## **Let's Reimagine Chief Street! – Concept Options**

## Port Road to Chief Street

## Option 1: “Shared use path” Option

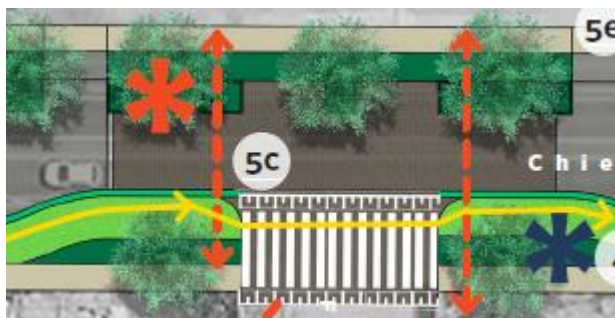
- The proposed streetscape section illustrates exactly the sort of situation cyclists dislike, with a pedestrian walking a dog on the path. Dogs are very unpredictable and having a degree of latitude, even when on a leash, that is sufficient to get in front of a cyclist and cause a crash.

- In more concrete terms, the path width of 2.8m is arguably narrower than desirable for shared use. From AGRD6A, 3.0m is also the desirable minimum width for a regional shared use path. Regional paths can also form part of a Principal Bicycle Network (in SA terms, the Bike Direct network – which would apply for Chief Street), in which case 3.0m would again be the desirable minimum width.  
(AGRD6A further notes that a width in excess of 3.0m may be desirable for a local access shared use path if “...there is a high probability of conflict between users (e.g. people walking dogs, in-line skaters etc.)” – which may be more debatable.)

- 2.8m for a two-way separated bike path plus 2.0m for a pedestrian footpath would be quite comfortable, and even more so given 2.0m footpaths on both sides of Chief Street.

## Second Street

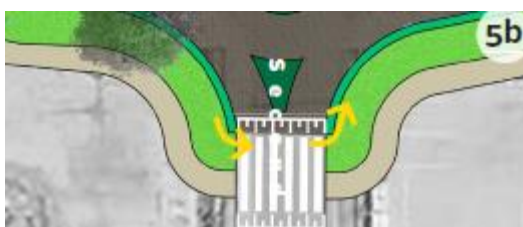
Given the known hazard presented to cyclists by roundabouts, we would prefer the raised threshold treatment. If a roundabout is countenanced, we recommend adopting radial design and note that our Vice Chair, Fay Patterson, has recently completed a PhD that (amongst other things) identifies a geometric risk factor for roundabouts to be hazardous to cyclists. We recommend that any roundabout design also take this into account.

While we generally appreciate the provision of the path around the roundabout, we note that the travel line is very tight for northbound cyclists. AGRD6A specifies a minimum radius of 2m for cyclist paths, which we doubt would be met in this instance.

As at Fourth Street, on either side of Second Street, the path bends in around on-street parking, bends back out to the travel lane and immediately bends in to pass around the roundabout. The tedious nature of this travel path for any path user is shown by highlighting it in yellow, below.

It would be somewhat difficult for cyclists from the western side of Second Street to join the bike path at this point.

The path could easily be straightened on either side of Second Street by not bending out past the parking, with street trees instead being planted on the outer (travel lane side) of the path.

### Ethelbert Square

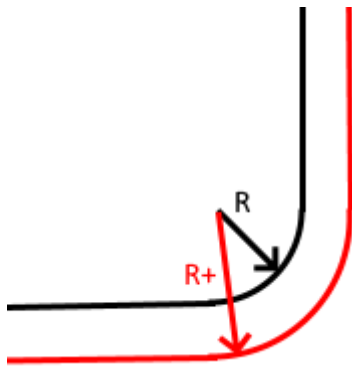
Our comments regarding the chamfering of the path at the wombat crossing of side streets and the bending out/in/out/in around on-street parking are similar as for Fourth Street.

A more desirable path alignment is shown indicatively following, in pink.

This demonstrates that:

- Street trees could be planted as proposed, separating the footpath from the bicycle path, but in a narrower verge area. Additional verge for landscaping would then be available at the kerb edge.
- Even with a landscaped separator between the footpath and the bicycle path, a straighter alignment could be achieved for the bicycle path.

## Fourth Street

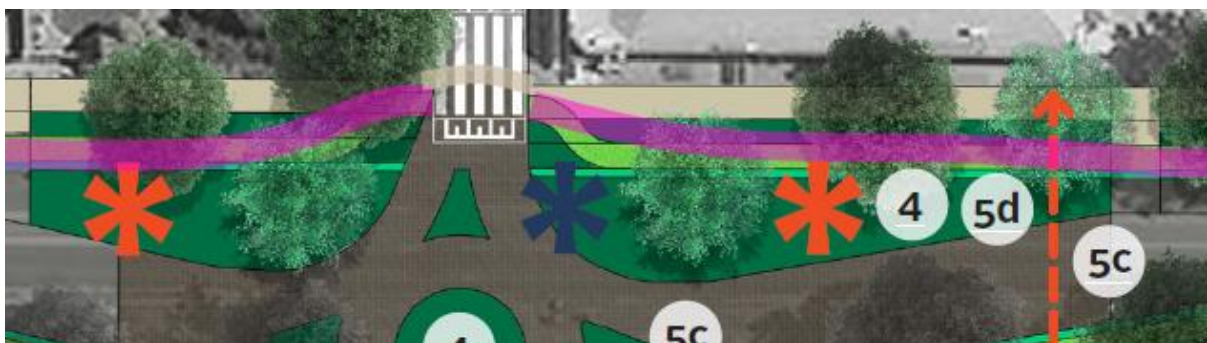
We assume similar alignment issues with the bike path and the ramp of the wombat crossing as for Option 1, with similar comments applying.

In addition, in this Option, path straightening, driveway location and reconsideration of parking may provide opportunities to provide 1.5m bike paths with overtaking opportunities, as sketched indicatively below. Pink = straightened, widened path (eastern side), additional width from use of buffer and driveway (western side). Yellow = reconsidered parking space.

## Ethelbert Square

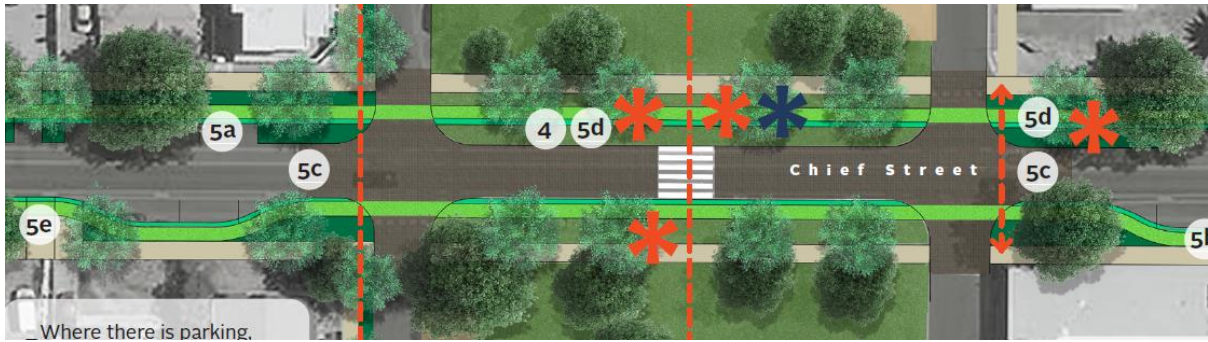
Similar comments as for Option 1 regarding the wombat crossings and alignment of eastern path, also extending to the western path.

This would be an area where paths could be provided at 1.5, with possible passing opportunities able to be developed.

- On the eastern side, apart from two car spaces, this situation extends to Hawker Street.
- On the western side, the frequency of driveways means that parking arrangements generally meet length requirements. These also present locations at which the bike path is functionally 1.5m.
- There are three locations where changing parking to meet length requirements could be strategically used to provide 9m lengths of at least 1.5m bike path and potentially 2.0m passing opportunities. This would be desirable because given a wide footpath with good access via driveways on the western side, and potentially low pedestrian levels, it is possible that the footpath would be used as a de facto overtaking (or slow vehicle turnout) lane if no formal passing opportunities exist.
